SRR-CWDA-2019-00028, Revision 0

GENERAL SEPARATIONS AREA GROUNDWATER FLOW MODELING

**Discussion Supporting NRC Onsite
Observation Visit
March 18-19, 2019**

Figure 8 [Comparison of SDF Pulsed Source Concentrations (concentration, C in Ci/L, time, t in years)]

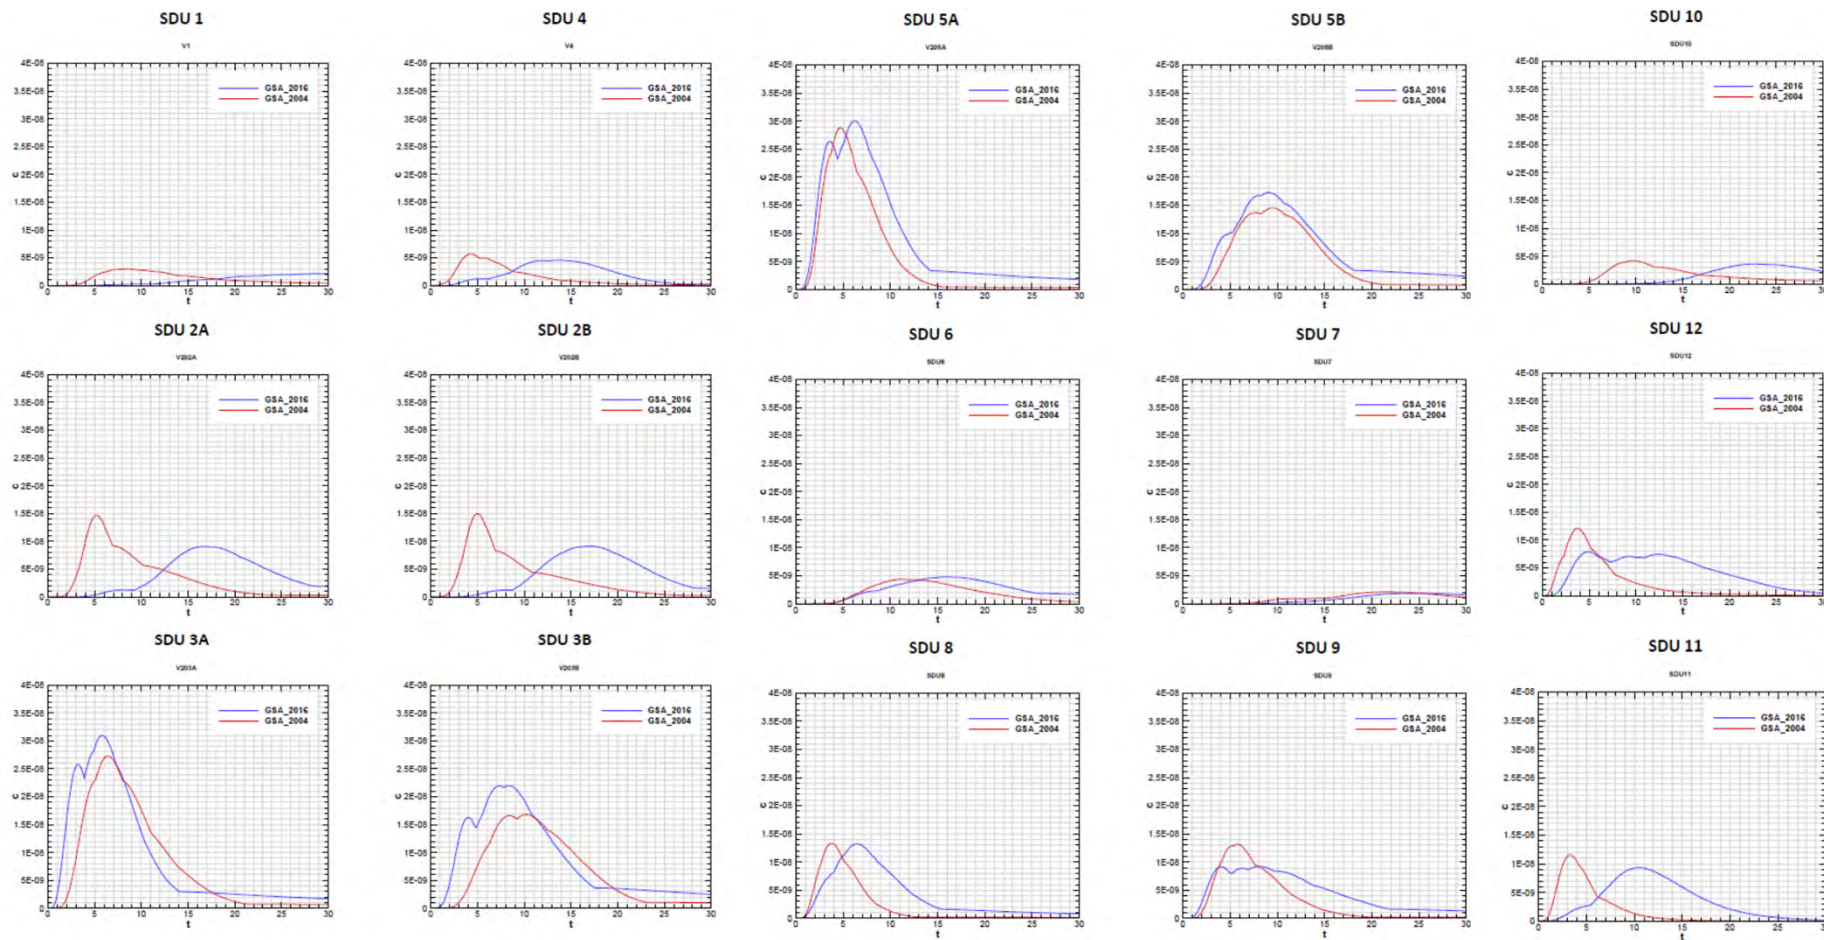
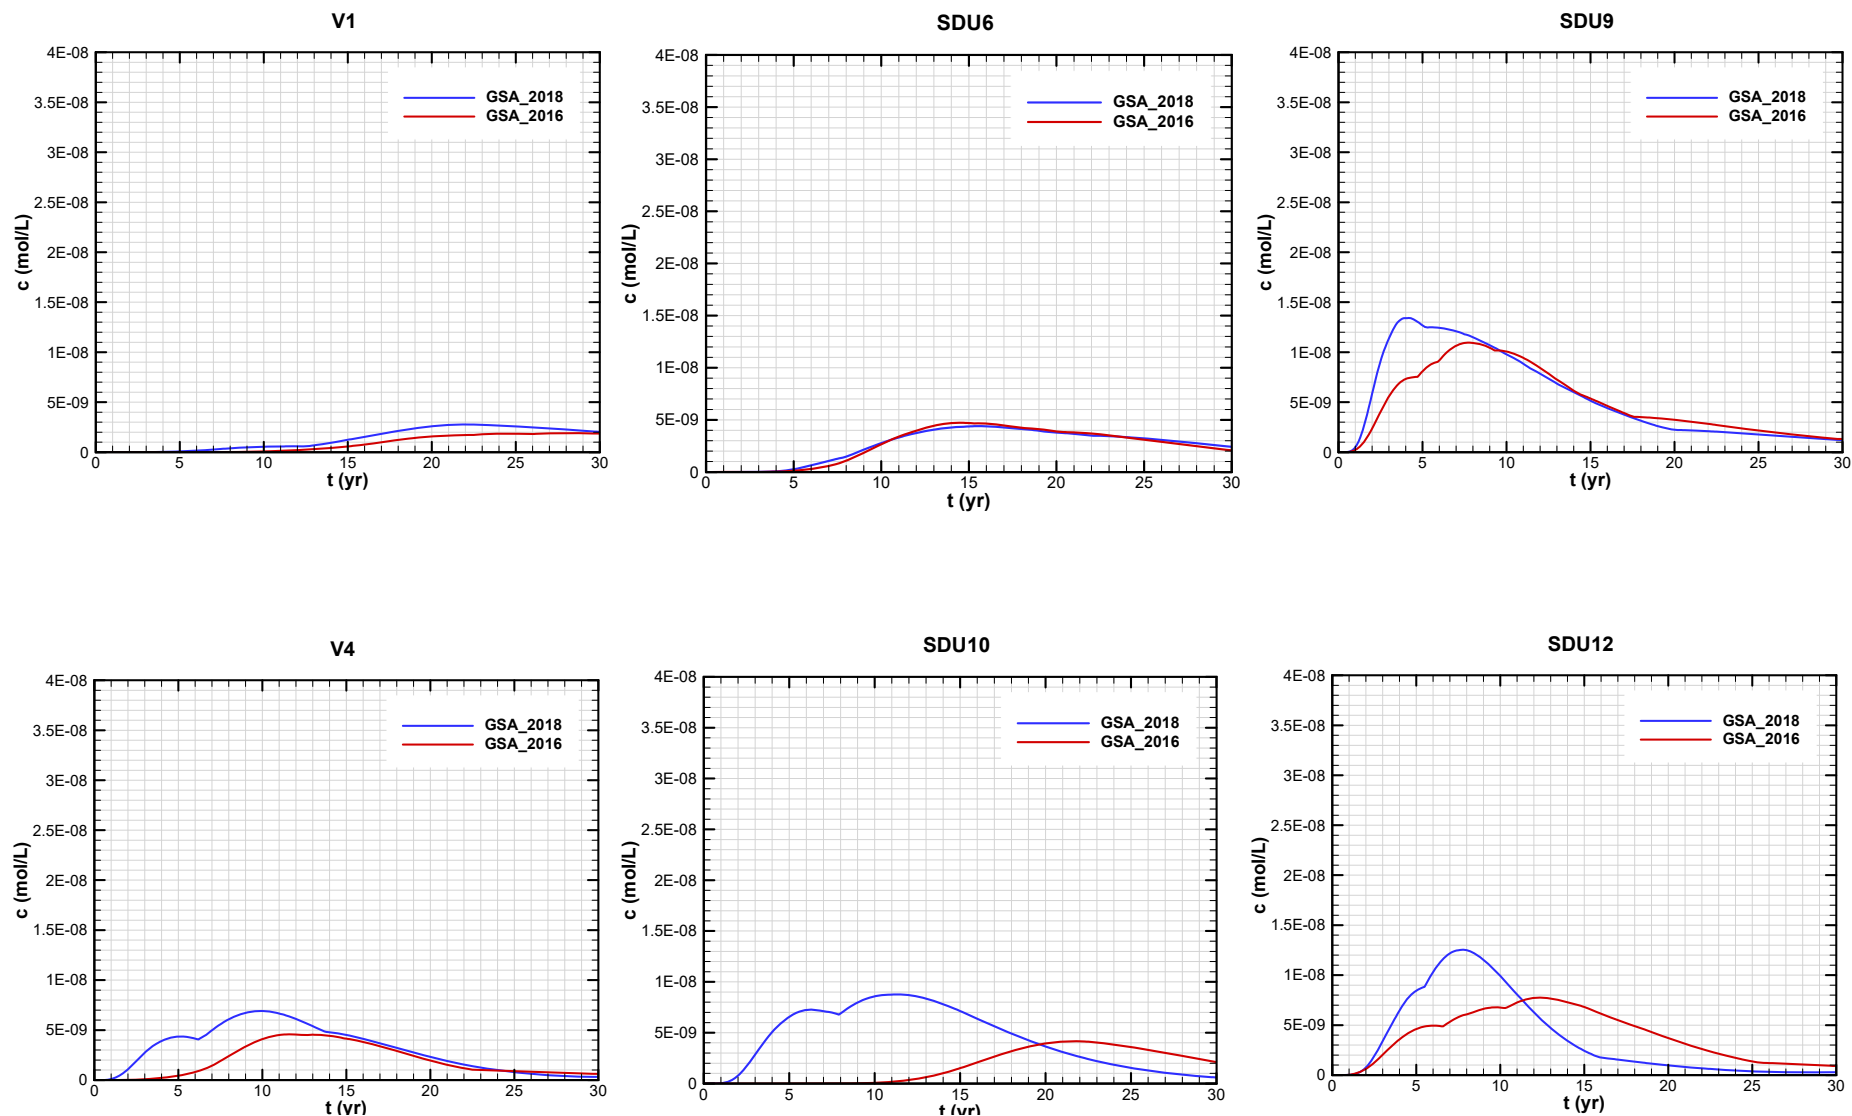
7. Discussion and comparison of Fig. 3 with Fig. 4.
[Slides 17-20; updated to GSA_2018]
8. Discussion plumes in Figures 4 and 5 (**5 and 6?**) and flow and transport influence of TCCZ.
[Slides 21-23; updated to GSA_2018]
9. Discussion on Fig. 8.
[Slides 24-25; updated to GSA_2018]
10. Where is the seepline located for Figure 10?
[Slide 26; updated to GSA_2018]

GSA_2018 versus GSA_2016 [#9]

Figure 3-1. Stratigraphy and permeability zones in the GSA2016 computational grid.

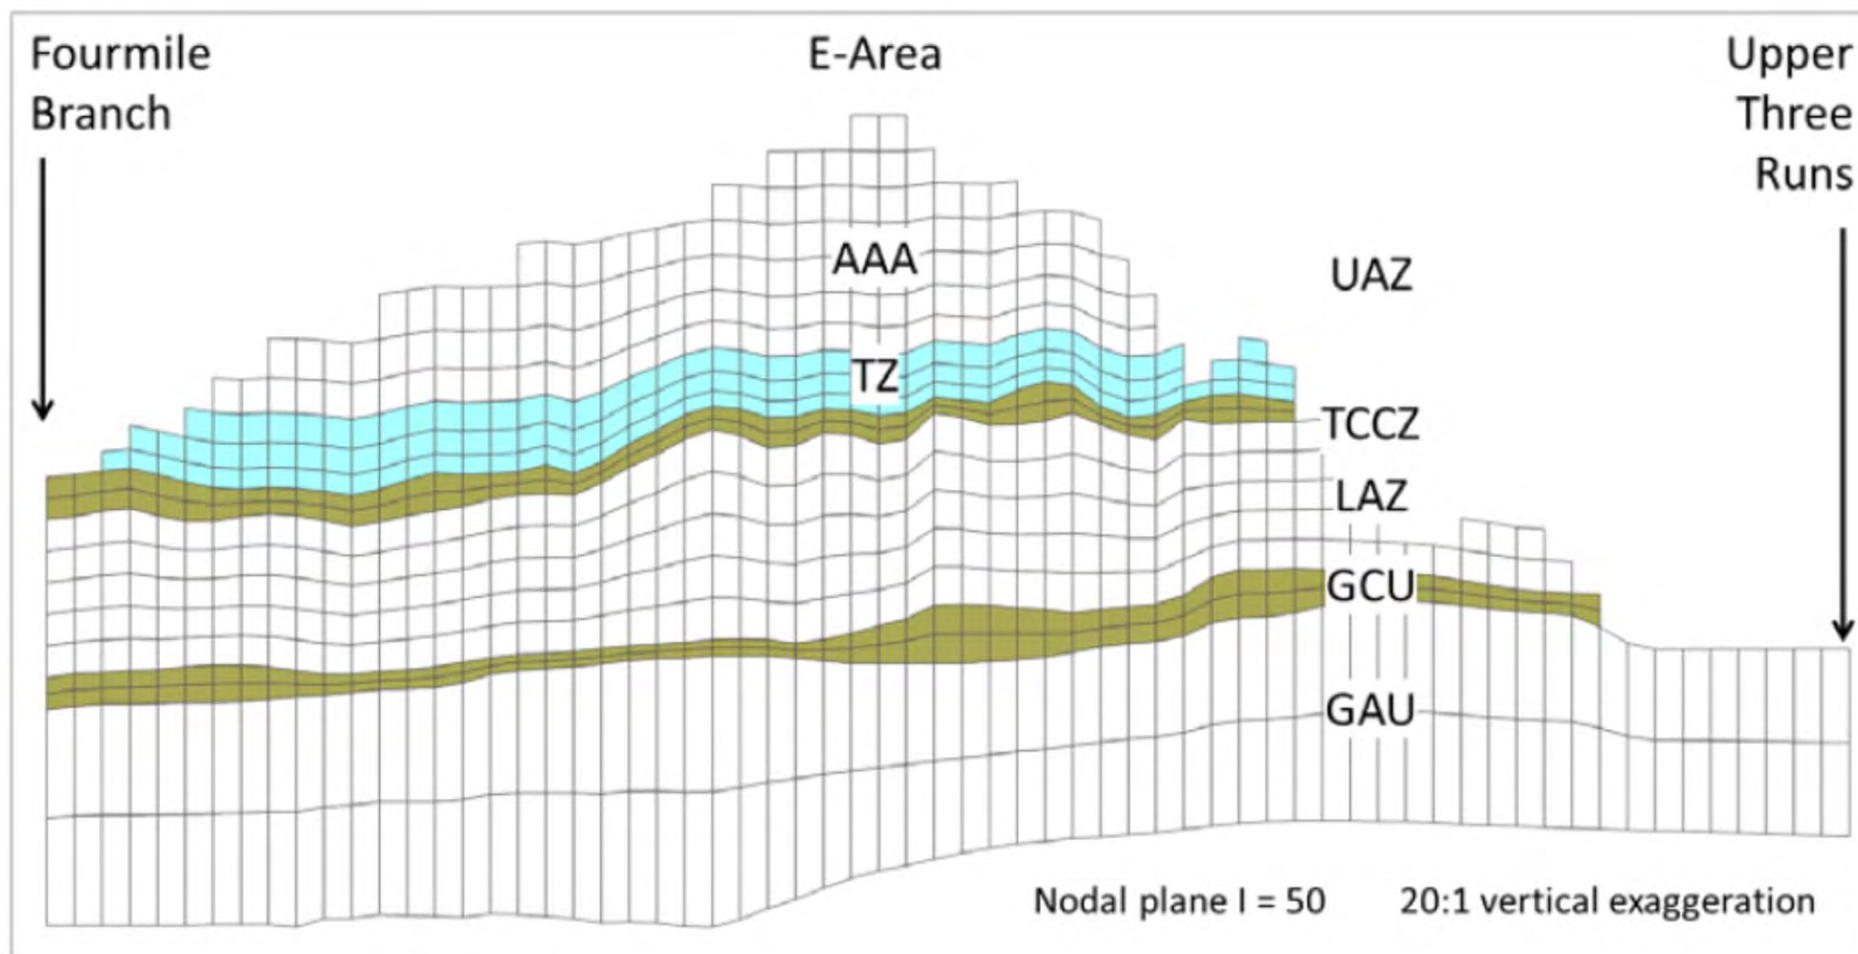
- 11.** Discussion of the technical basis for subdividing the Upper Aquifer Zone into a Transmissive Zone (TZ) and a combined A and AA zone (AAA). Discussion on the hydrogeologic conceptual models associated with the F-Area seepage basins, Old Burial Ground, and H-Area seepage basins as presented in WSRC 2000, SAIC 2000, and SRNS 2017, including exclusion of H-Area and Z-Area.

Figure 3-2. Simulated groundwater pathlines for GSA_2016 model prior to placement of low-infiltration covers.

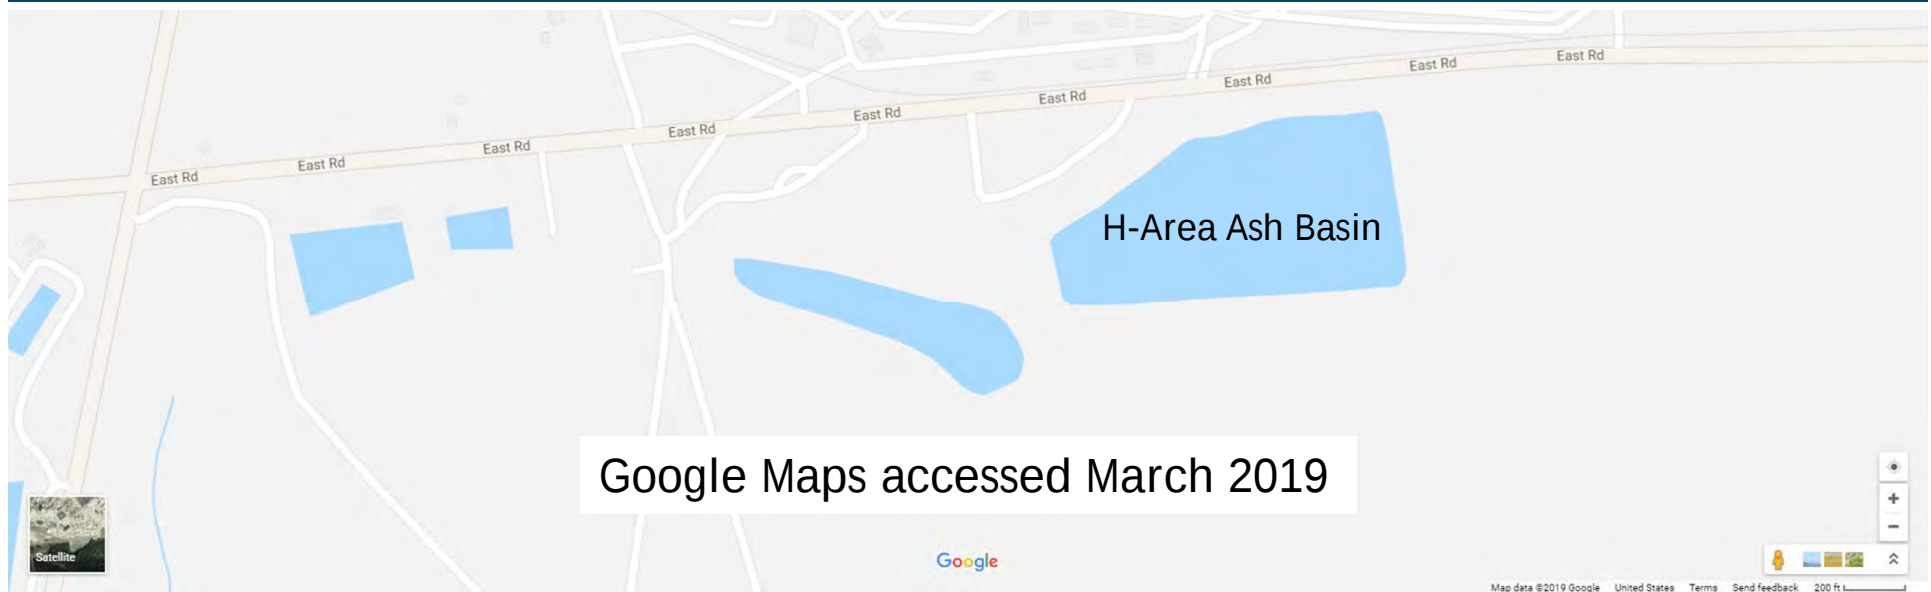
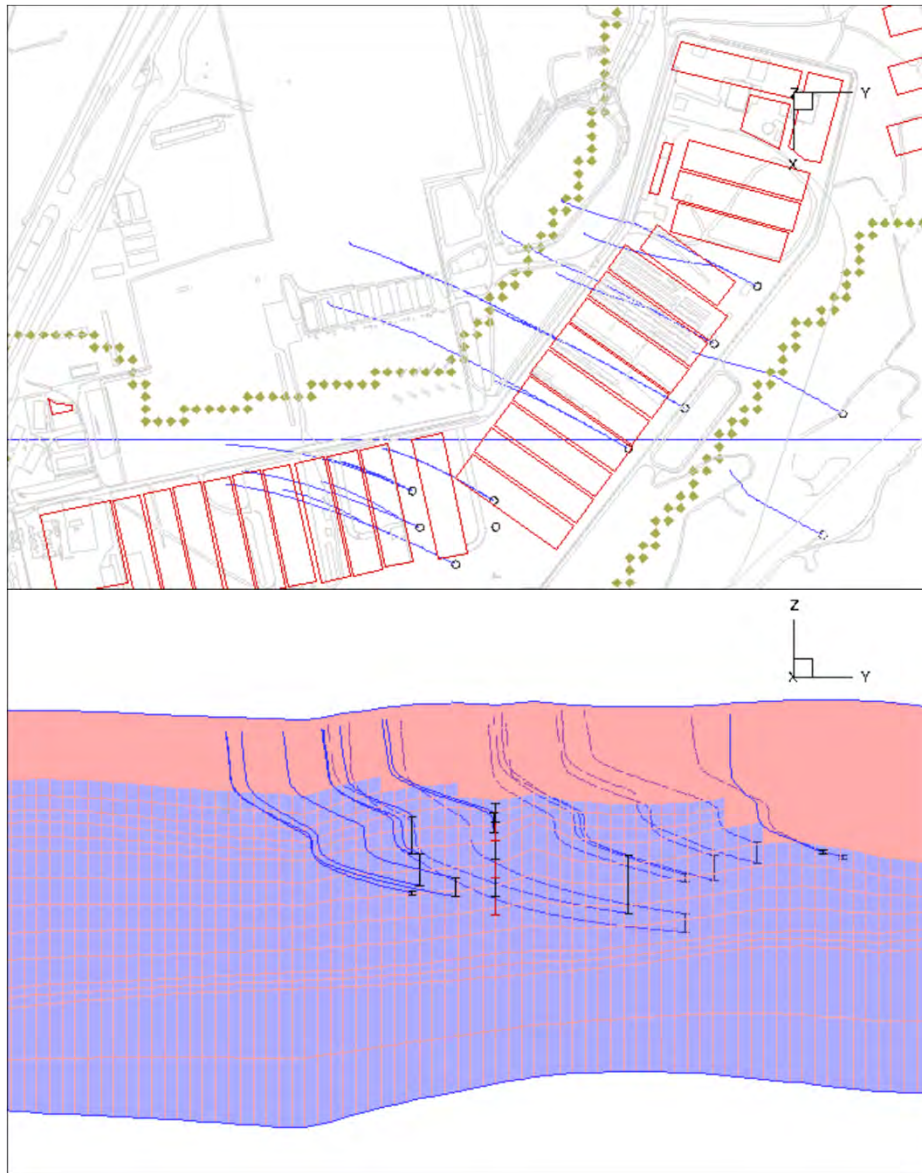
14. Discussion of unsaturated flow paths as presented in Figures 3-2 thru 3-5.

Figure 2-8. Example velocity field showing predominantly downward flow in the vadose zone; vectors are fixed length showing flow direction only.

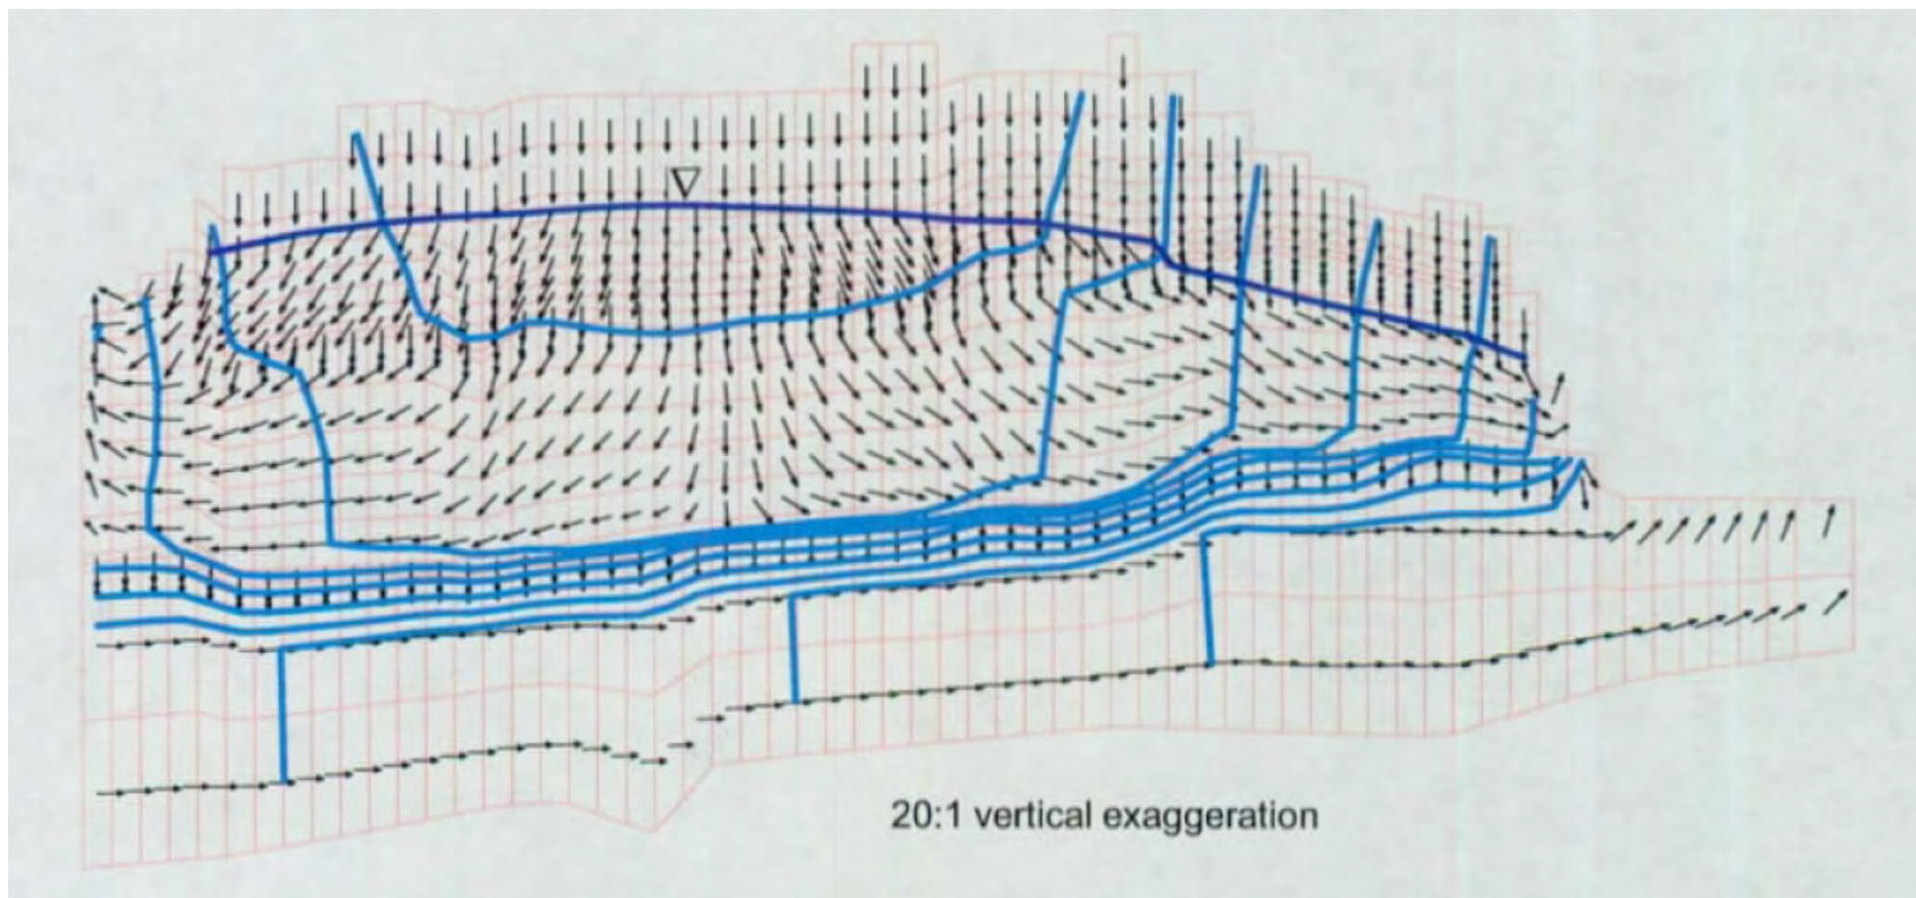
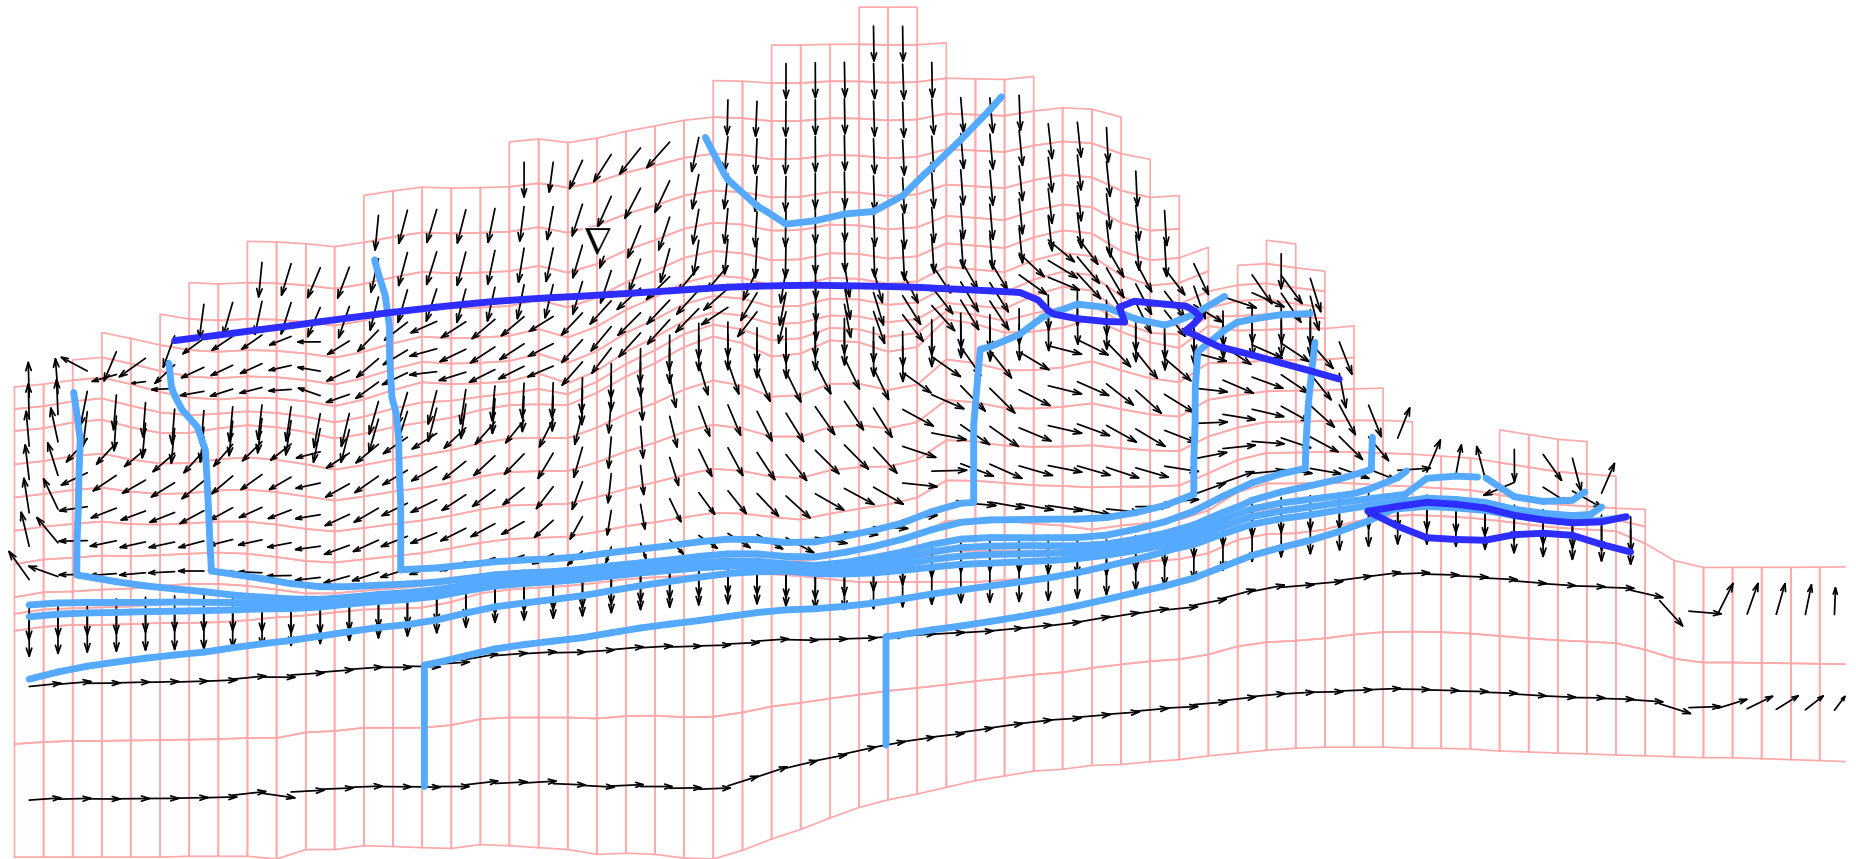
15. Can a velocity field figure be generated and provided from the 2018 GSA model, similar to that shown in WSRC-TR-2004-00106 Figure 2-8, but with an orientation that is perpendicular to that shown in Figure 2-8?

Same grid index as Slide 35, but shifted physical location

20:1 vertical exaggeration
